3 - 6 Spring Place
Spring Place Ltd

Comments Response
South Facade
November 2016

South facade of submitted proposal

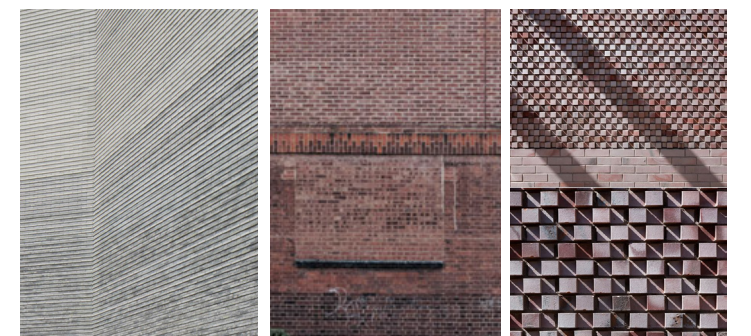
Following comments from LBC, it was agreed to further investigate the treatment of the southern facade to achieve a level of solidity typical of these kinds of flank, 'party' walls. The previous iteration (adjacent) was considered by LBC to be more successful. It was considered that the depth of these opening and recesses was appeared rather shallow in contrast to the Spring Place facade.

In order to achieve texture as well as a subtle marking of the south east corner of the building, the updated proposal features a window of the same dimensions as those to Spring Place with a perforated brick screen in front.

In this way the solidity of the wall is maintained while celebrating the craft and beauty of the brickwork to this facade.

The scale of this opening is better in keeping with the Spring Place frontage and will change character/transparency depending on the time of day.
